## **Addendum 2**

# **Kate Furbish Elementary Discovery Classroom**

**75 Jordan Avenue  
Brunswick, Maine**

**Kate Furbish Elementary – Discovery Classroom**  
**Brunswick, ME**  
**Addendum #2**  
**04/17/2020**

**SK-1**

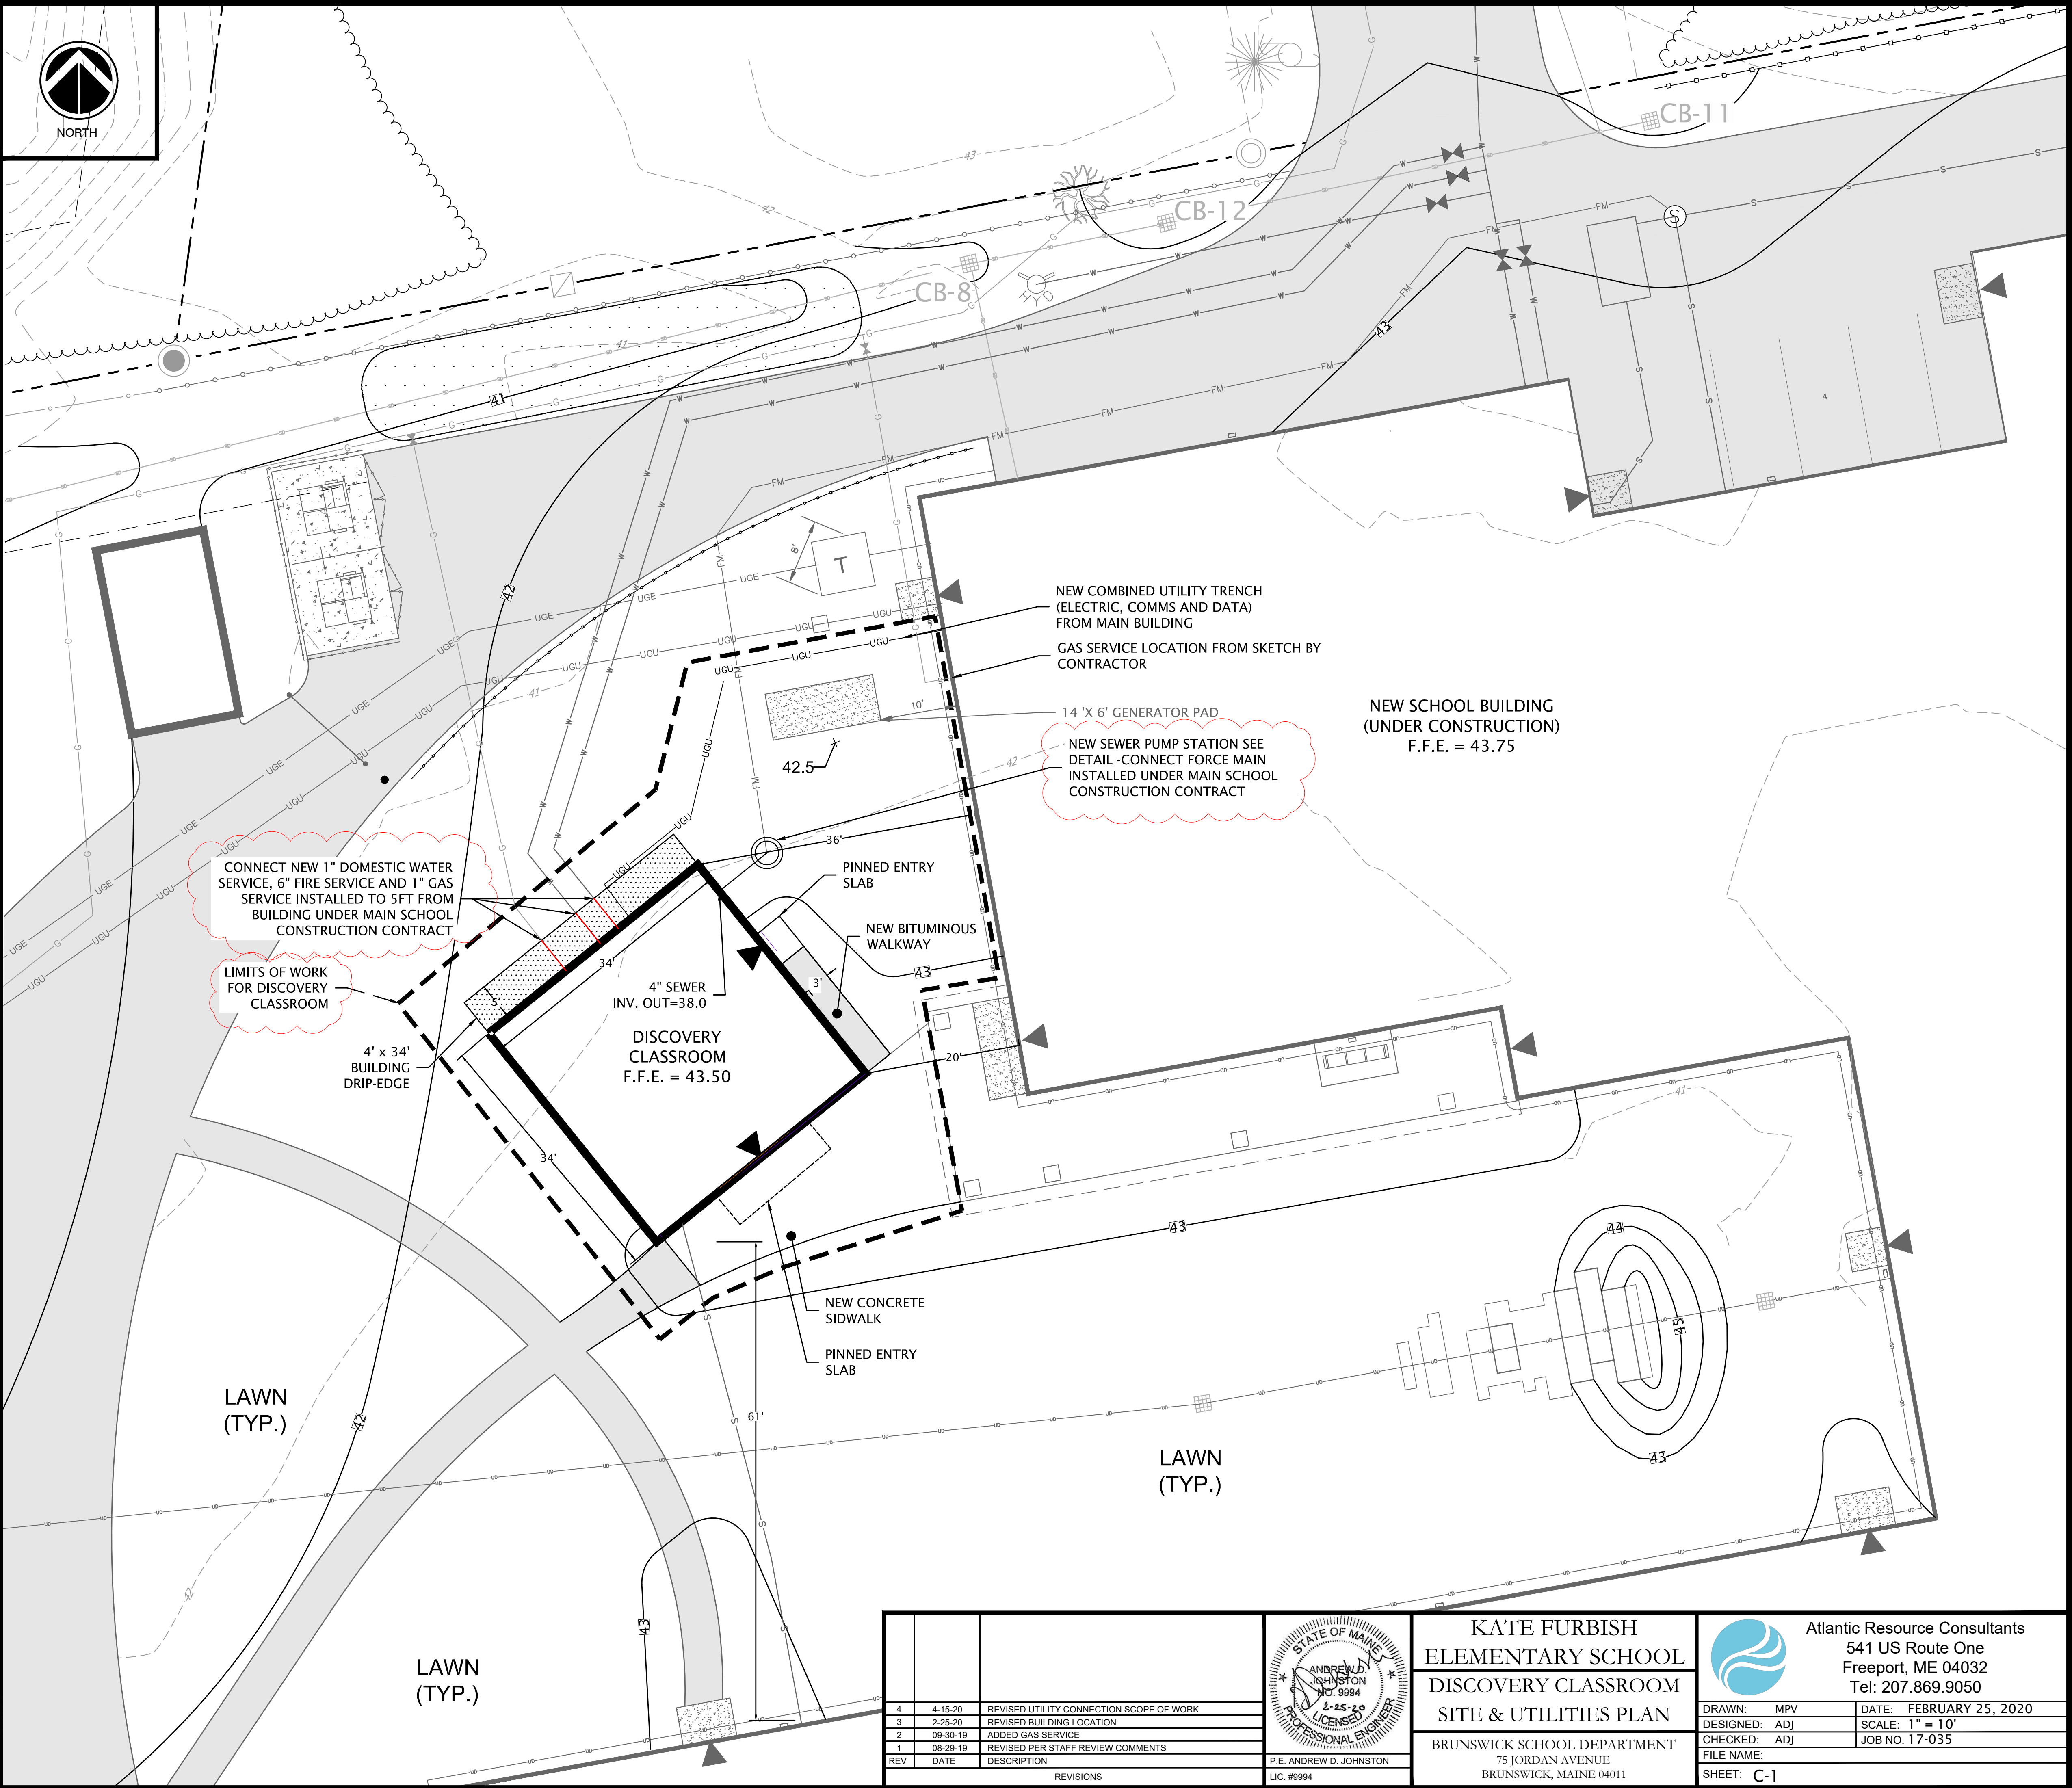
- Q.** There is no detail for the pavement or gravel thickness in the driveway. Even if there is no paving to do I need gravel depth. Assuming 18".  
**A.** Please see Part I Addendum to Civil Specifications and Drawings for clarification.

- Add heavy duty pavement detail per **SK-I**.

TITLE  
OVERALL RCP

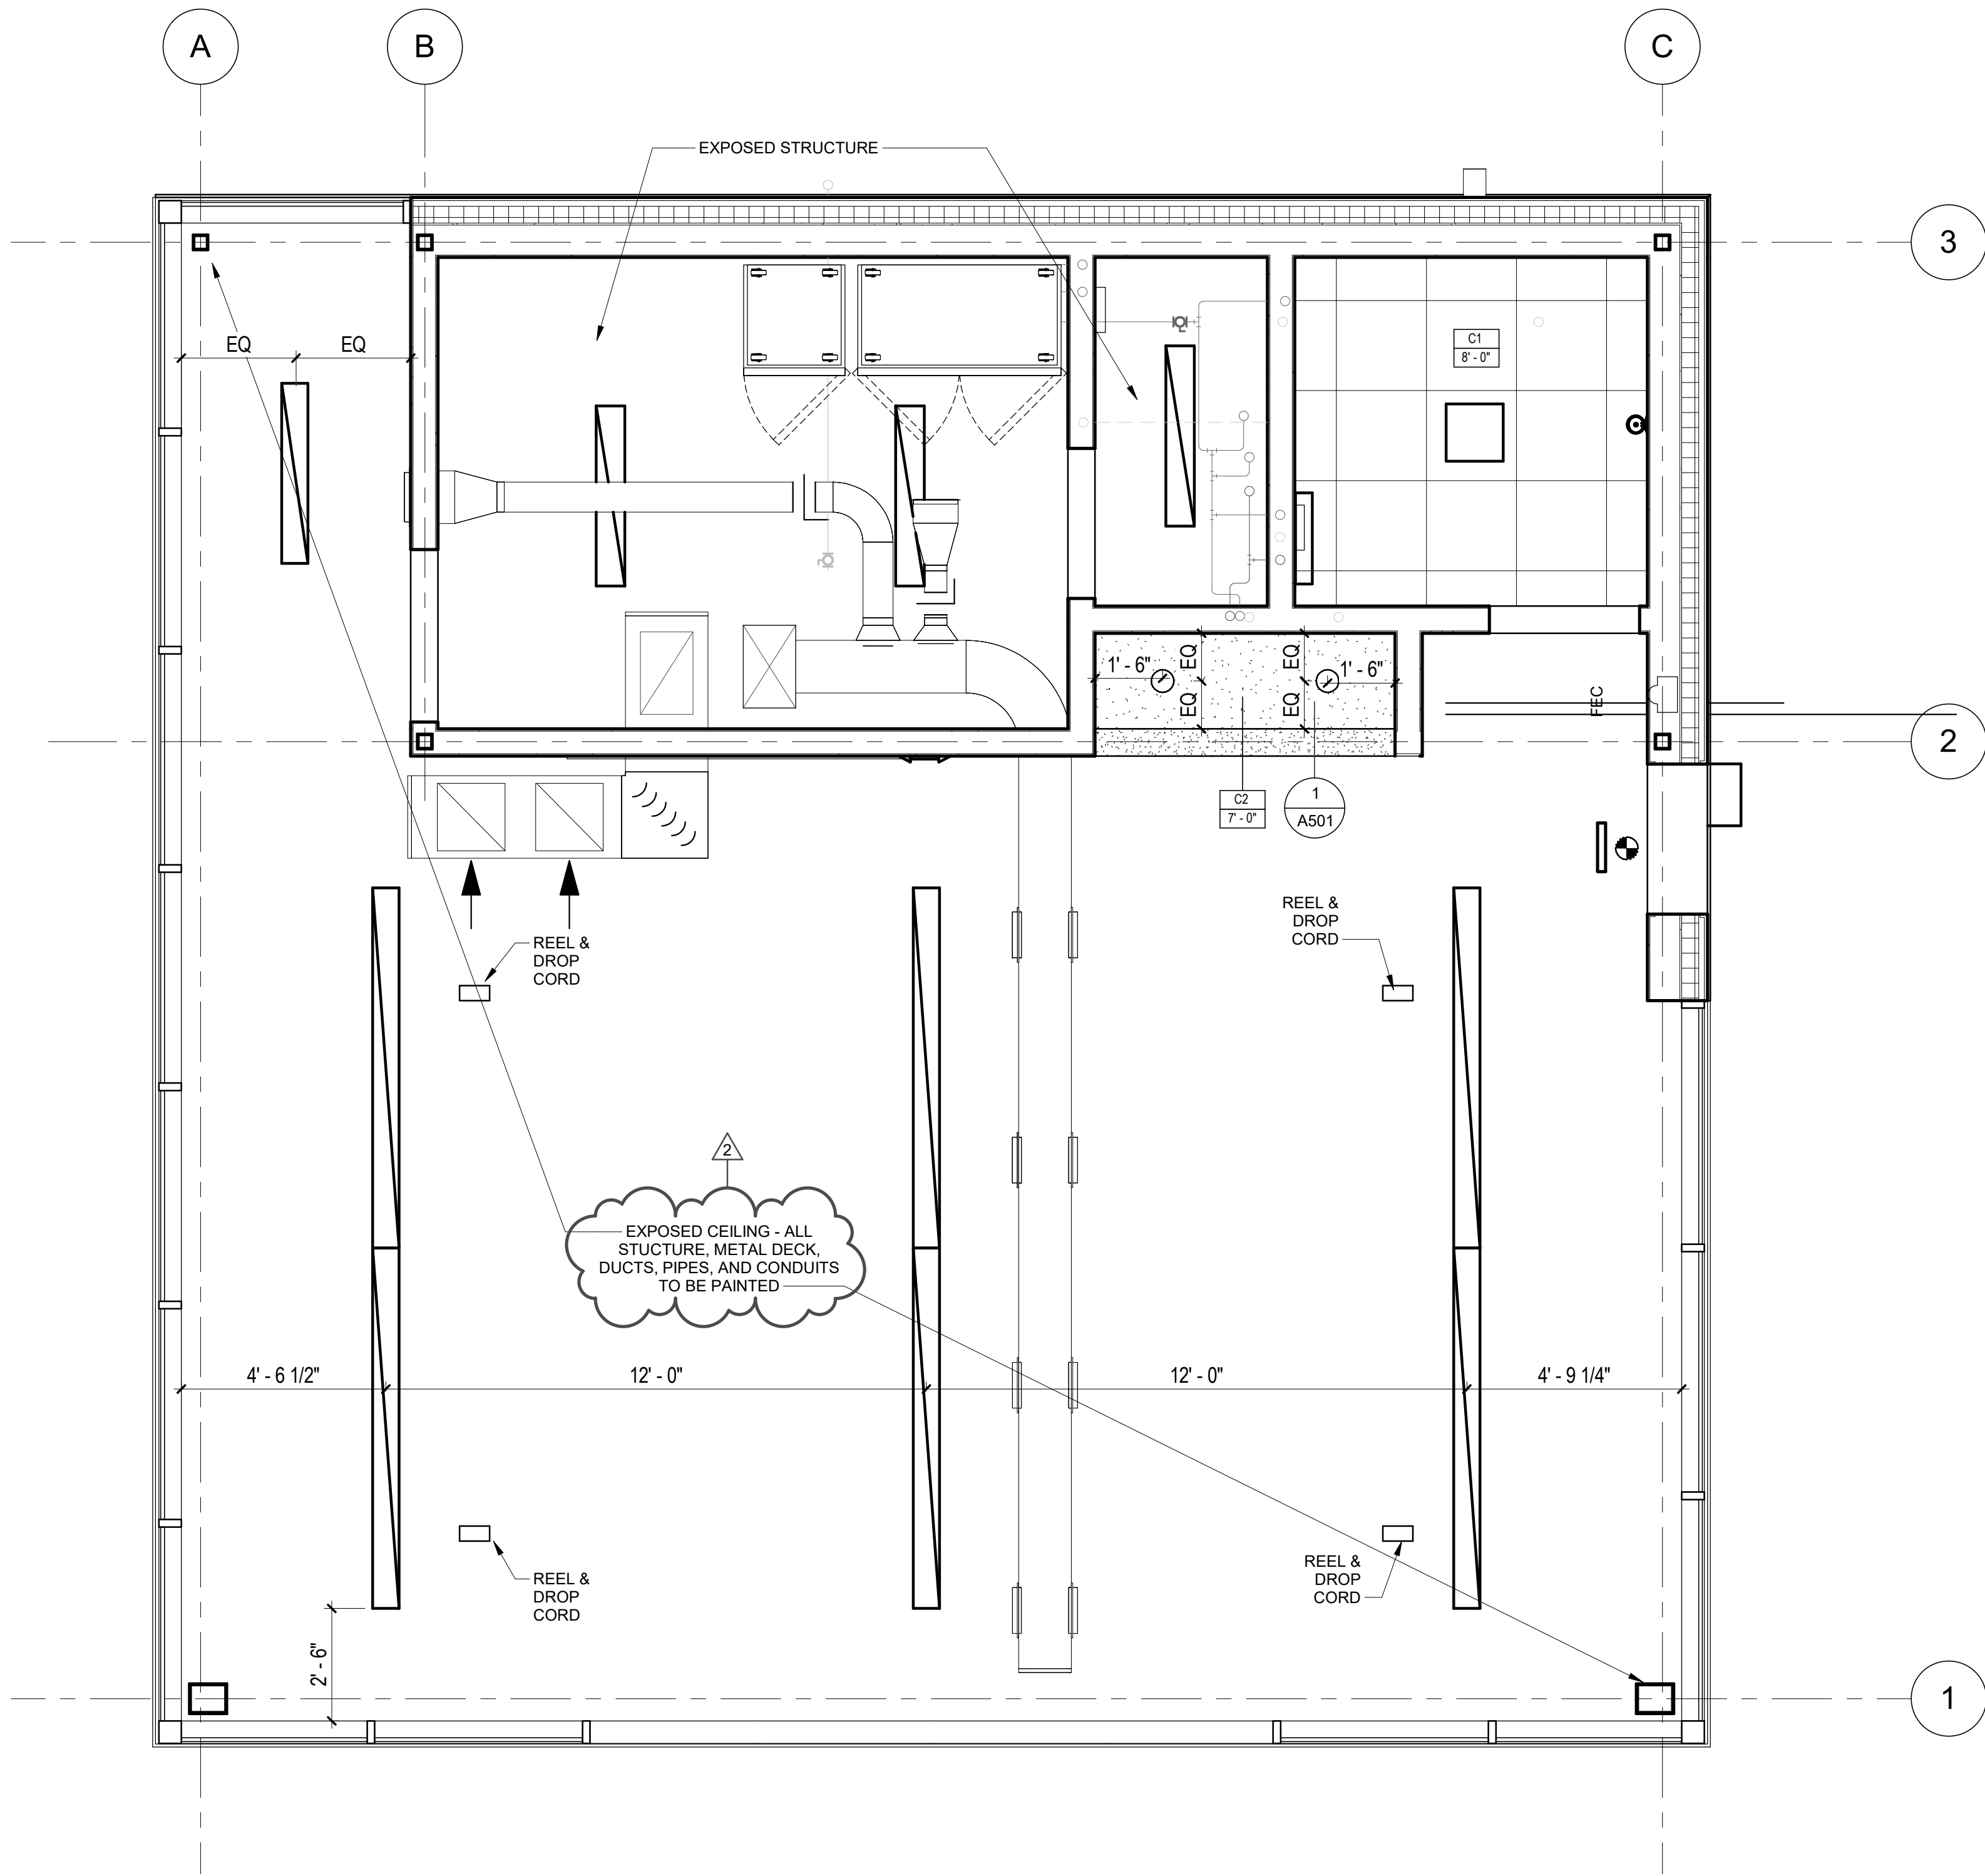
- A.** Either is acceptable, 46 KSI min.
- Q.** Spec's Part 2 Section 2.03 Structural Steel Coating on page 151200-8 G. General: Shop prime of structural steel is not required for heated, interior steel not exposed view unless noted otherwise. The only painting of steel is All Structural on Line 1, All Structural on Line A, Pant Steel between A&B on Line 3, and Paint Steel between 1&2 on line 3?

- A.** Exposed structure in rooms Storage 101 and Utl. 101A are to be left raw. All other exposed structure to be painted. See Part III Addendum to Architectural Specifications and Drawings for further clarification.

**Sheet A111 – Overall RCP**

- Revise note from “Exposed structure, painted” to “Exposed ceiling – all structure, metal deck, ductwork, pipes and conduits to be painted.”
